ATTACHED TO ADMINISTRATIVE APPROVAL
 DATED: November 18, 1999
 BY: MARTIN R. CRAMTON, JR.
 99-73

JEFFERSON SQUARE SITE PLAN
 1"=20'-0"

JEFFERSON SQUARE

SUBJECT: Administrative Approval for Petition No. 99-73, Capitol Funds, Inc.

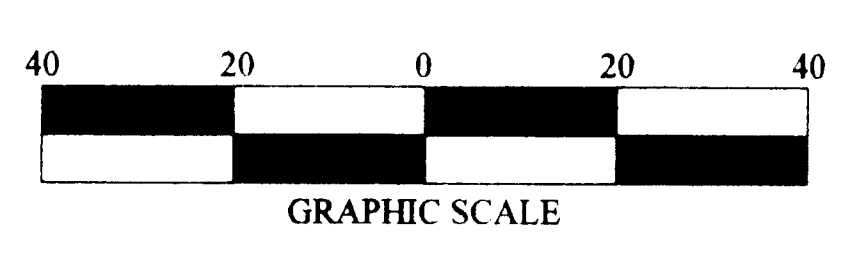
Project	98262.007
Drawn	
Checked	
Date	15-MAR-99
Revised	25-MAY-99
	23-JUNE-99
	1-JULY-99
12-NOV-99	- unit count from 74 to 75 units

Attached is a copy of the revised plan for the above rezoning petition. The plan has been revised to add one additional unit to allow a maximum of 75 units. This is the only change from the originally approved plan. Since this change is minor, I am administratively approving this revised plan. Please use this revised plan when evaluating requests for building permits and certificates of occupancy.
